# Technical Service Bulletin

## 21 MIL on (DTC P0299 - negative pressure deviation); turbocharger excessive wastegate play

21 14 18 2031245/7 June 6, 2014. Supersedes Technical Service Bulletin Group 21 number 13-16 dated July 9, 2013 for reasons listed below.

**Figure 2.** Fit the clip from the side.

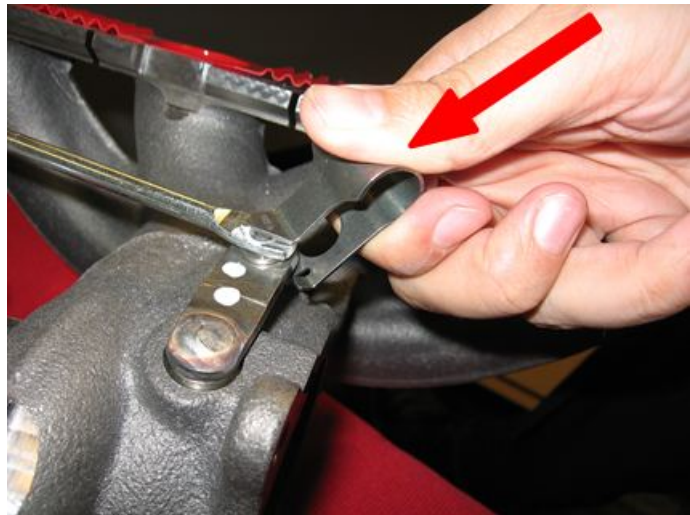
2. Remove turbocharger according to the instructions in ElsaWeb: *Repair Manual >> Engine / Engine Mechanical >> 21 Turbocharger, G-Charger >> Removal and Installation >> Turbocharger.*
3. Install clip **06J145220B** on a new, replacement turbocharger's link plate and actuating rod joint as illustrated (Figures 2 and 3).

**Figure 4.** (1) Maximum opening of clip, (2) Position of original circlip

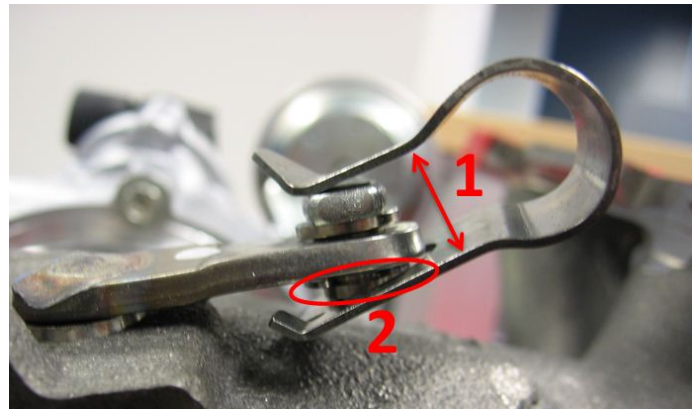
- The spring clip must not be overstretched. The maximum opening of the spring clip is 14 mm (Figure 4, 1).
- The spring clip must be replaced after every removal.

**Figure 5.** Correctly-fitted clip.

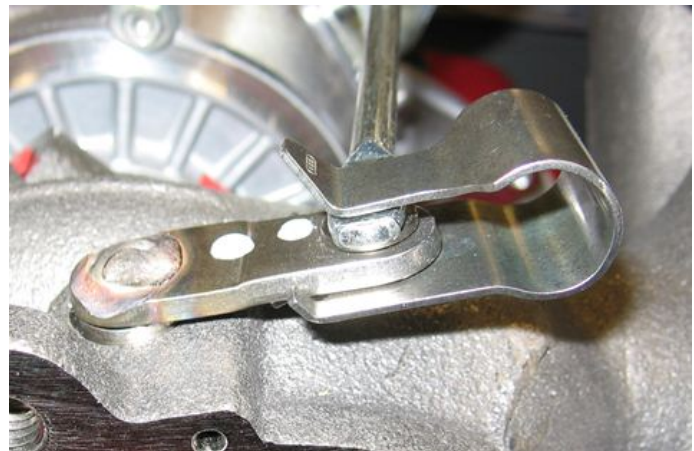
5. After fitting the spring clip, check for correct fit (Figure 5).

**Figure 6.** (1) Maximum opening of clip, (2) Position of original circlip

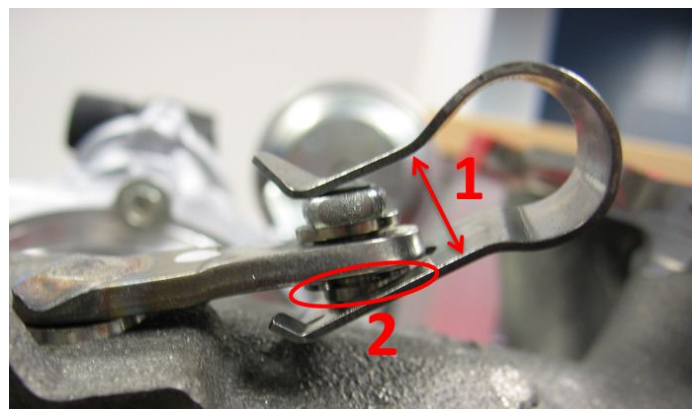
6. After fitting the spring clip, check the position of the original circlip (Figure 6, 2) and correct it if necessary.
